**ETS 300 347-1**  
pr **A1**

**This draft amendment A1, if approved, will modify  
the European Telecommunication Standard ETS 300 347-1 (1994)**

**Signalling Protocols and Switching (SPS);  
V interfaces at the digital Local Exchange (LE);  
V5.2 interface for support of Access Network (AN);  
Part 1: V5.2 interface specification**

Page 206, figure L.18.2

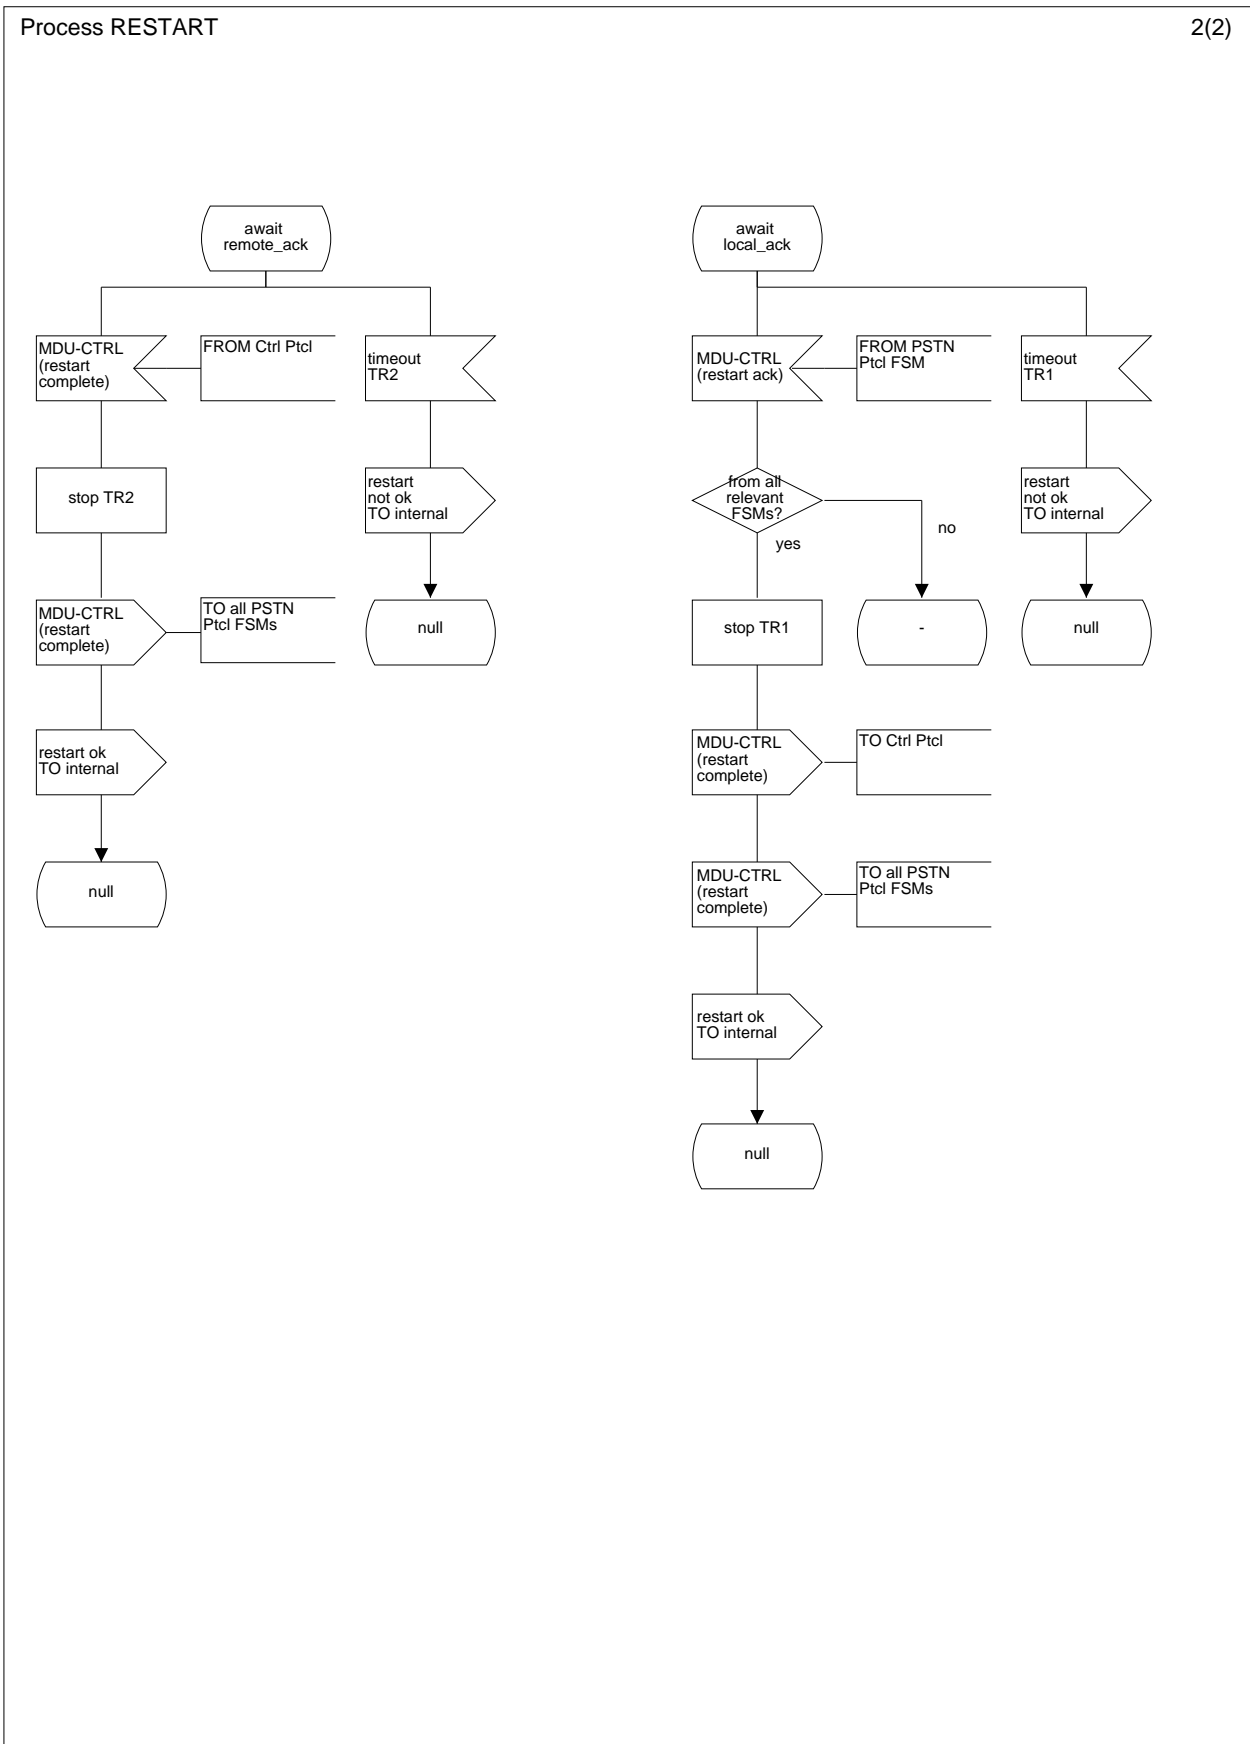
Replace the complete figure.

Figure L.23a.1: Accelerated port alignment procedures AN-side (sheet 1 of 4)

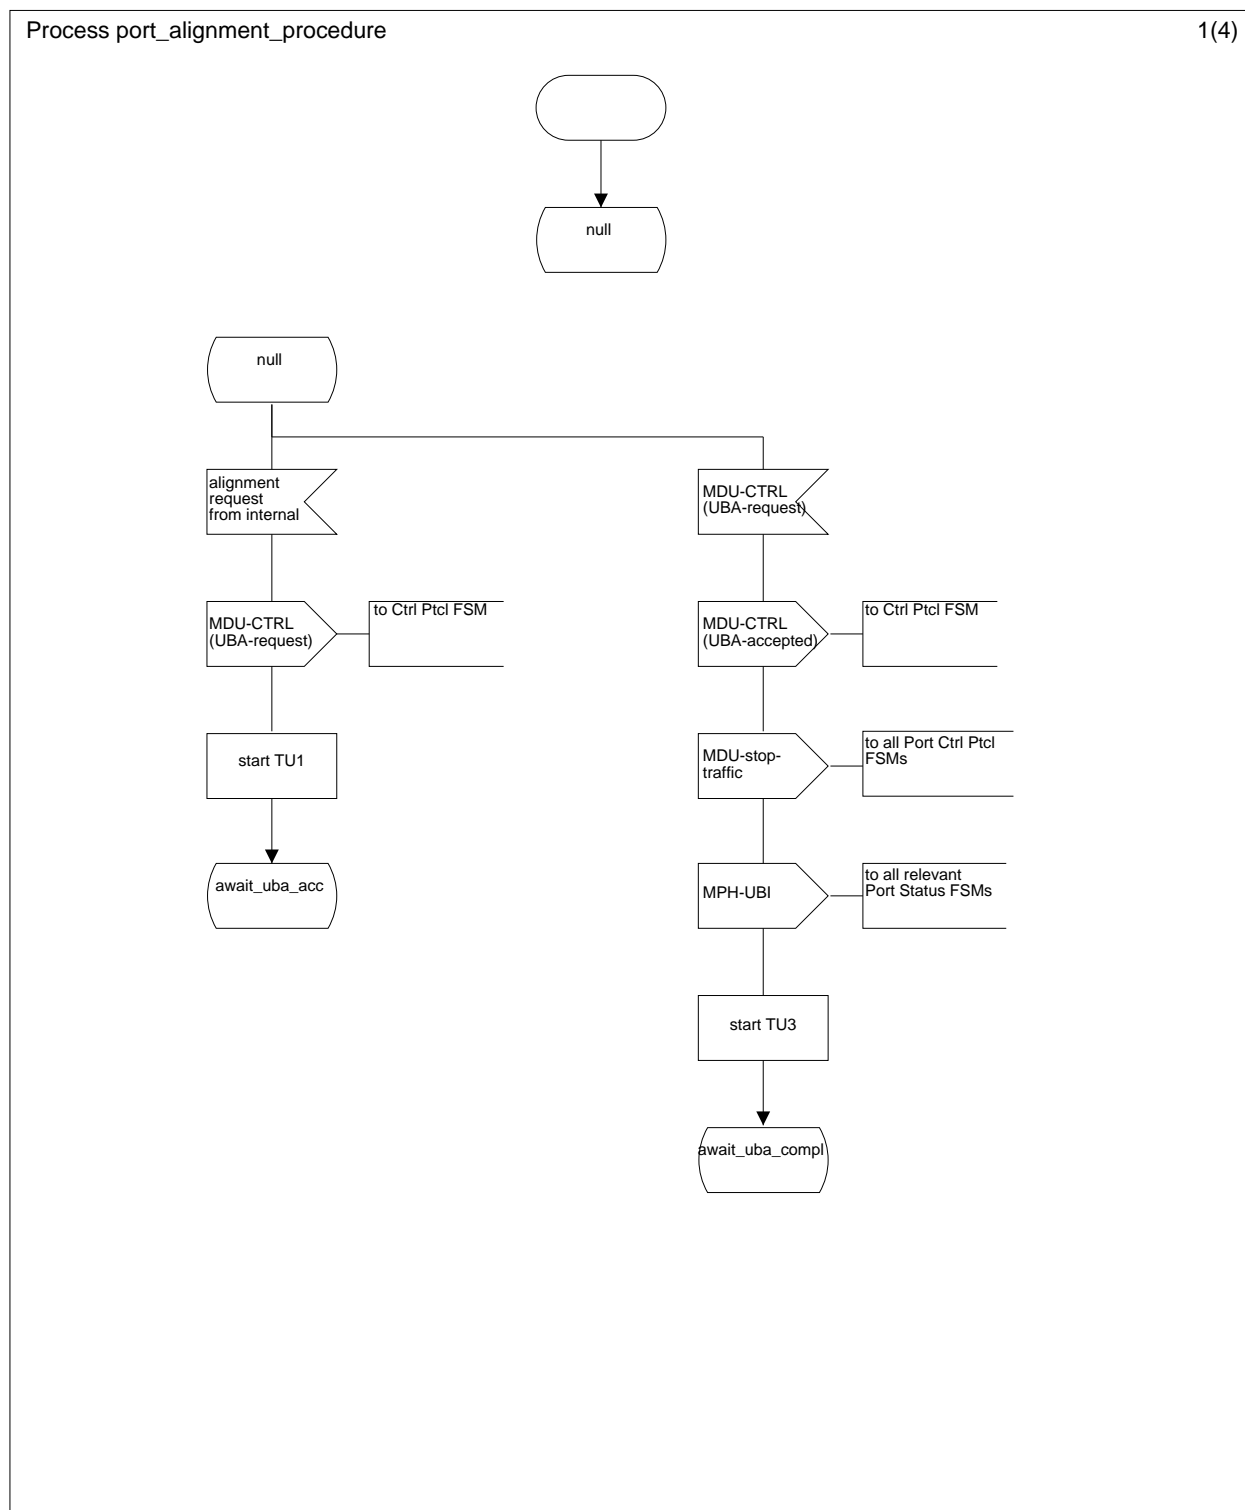
Insert a new subclause L.1.8.7 after figure L.23.3

Page 220, figure L.29

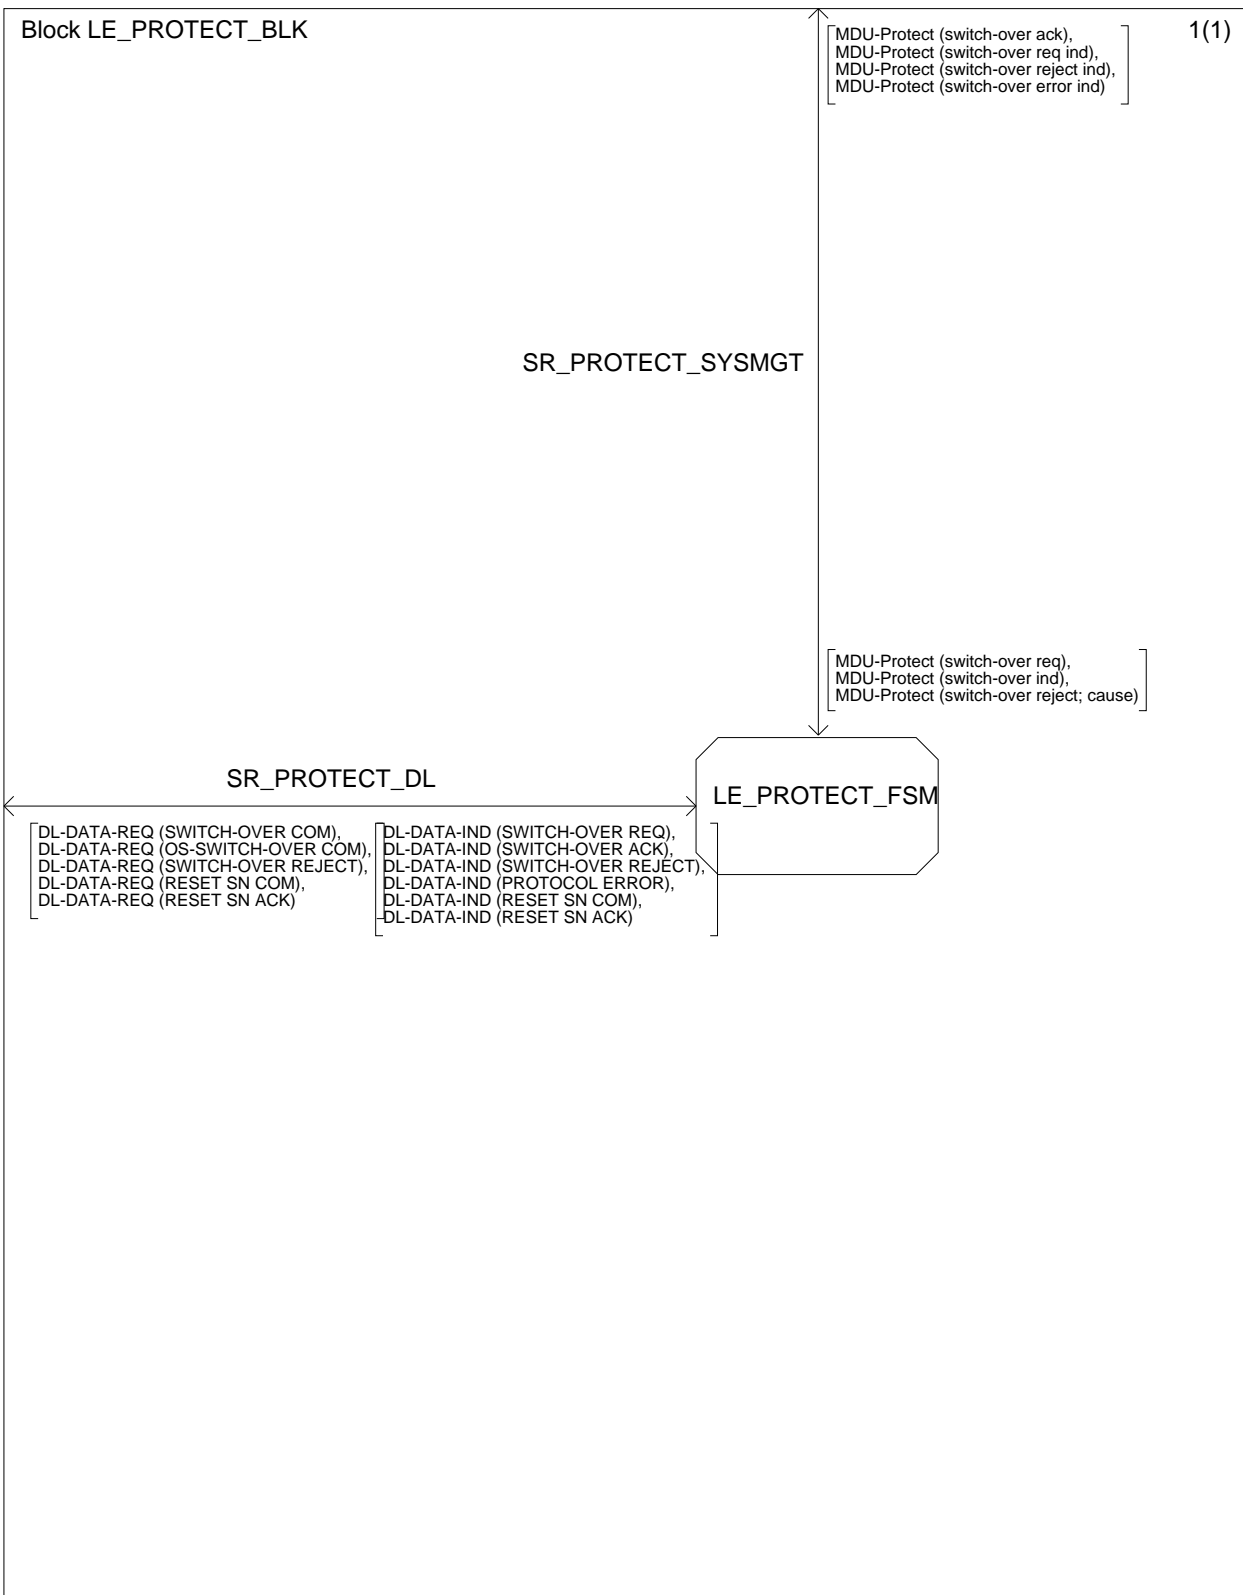
- Annex L, figure L.29: Some MDU-Protection primitives are missing for SR\_PROTECT\_SYSMGT: reset SN com, reset SN ind, reset SN ack, reset SN req and Protocol error indication.

Replace "switch-over req ind" by "switch-over req" for signal route SR\_PROTECT\_SYSMGT, upper signal list.

Add the following MDU-Protection primitives for signal route SR\_PROTECT\_SYSMGT, upper signal list: reset SN ind, reset SN com, reset SN ack, reset SN error ind and Protocol error ind.

Add the following MDU-Protection primitives for signal route SR\_PROTECT\_SYSMGT, bottom signal list: switch-over com, OS-switch-over com and reset SN req.

Delete the following MDU-Protection primitives for signal route SR\_PROTECT\_SYSMGT, bottom signal list: switch-over req.

Page 229, figure L.33.2, state "IN SERVICE"

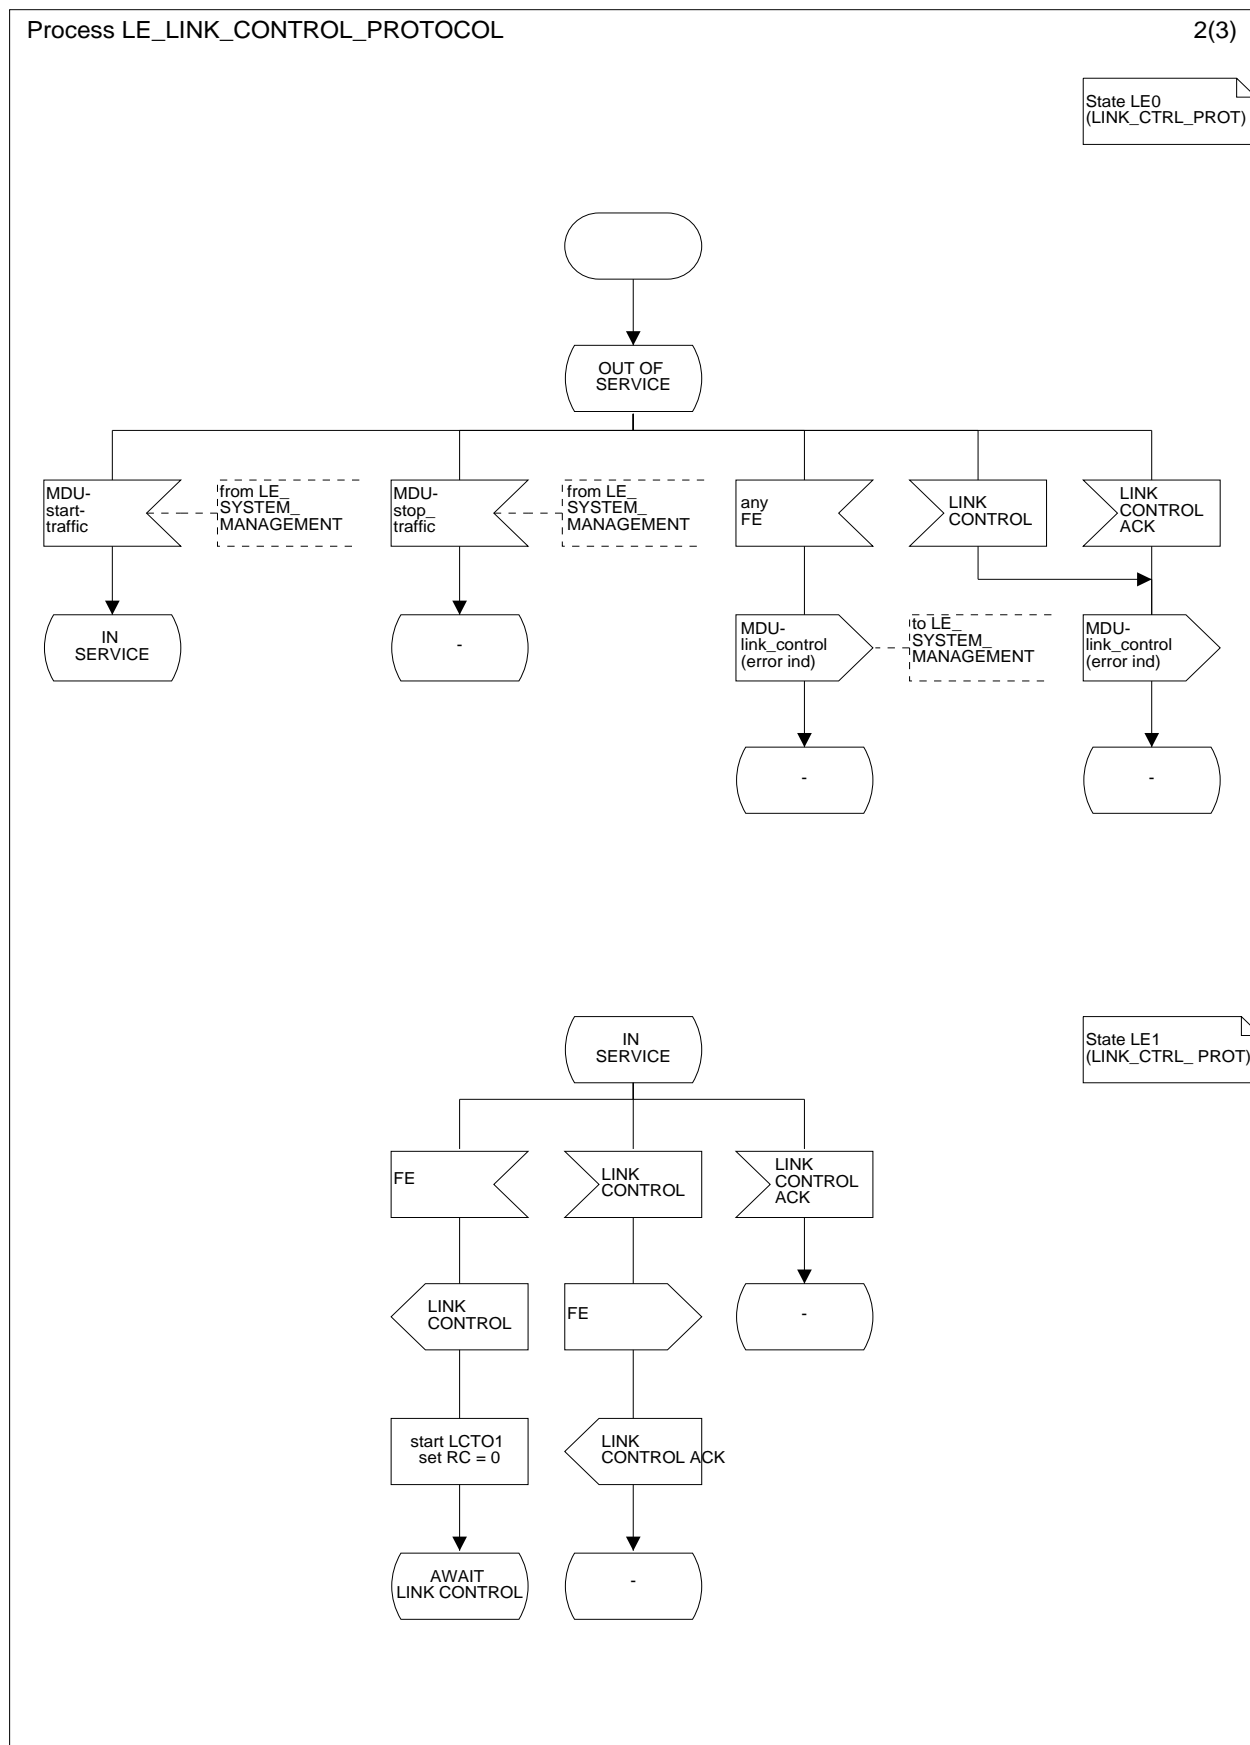
- Annex L, figure L.33.2: In the bottom diagram, the symbol for the message LINK CONTROL ACK has the wrong direction.
- Annex L, figure L.36.4: The cause for start of timer TSO4 is misalignment of sequence numbers VP(S) or VP(R) and repetition at the first timeout. Initialization of the sequence numbers V(P) or V(P) is only done in the procedure for misaligned handling according to figure L.14. This procedure is applied at the AN side and LE side.

Flip the input symbol "LINK CONTROL ACK".

Page 246, figure L.36.4

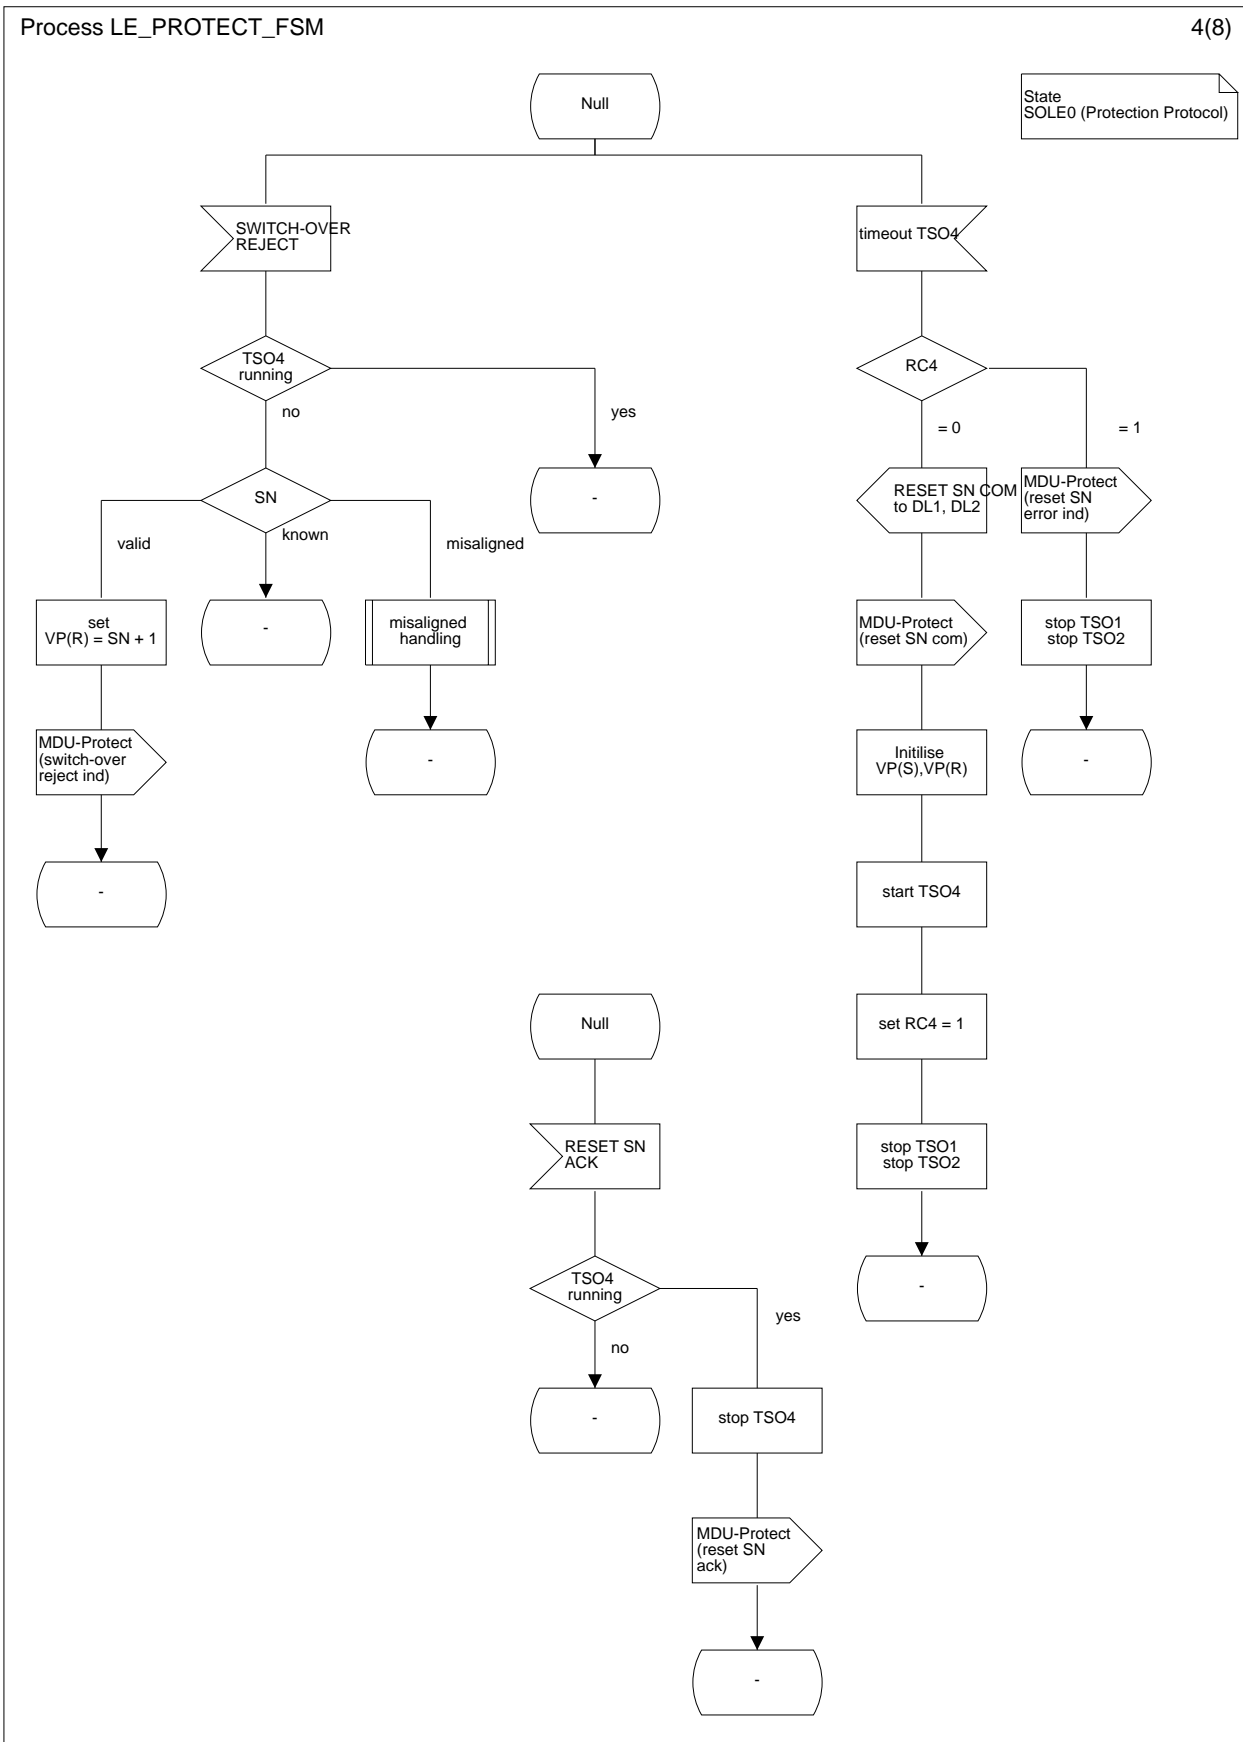
- When a misalignment is detected and TSO4 is running, there will be no further protocol messages apart from RESET SN COM. Therefore, the sequence numbers remain in their initialization values.

- Amendment: Both figures L.13.4 and L.36.4 are corrected with a task symbol to initialize VP(S) and V(P) before start of TSO4.
- Annex L, figure L.36.5: A stop of timer TSO2 is missing in the bottom left branch.

Add the task symbol "initialize VP(S), VP(R)" before task symbol "start TSO4".
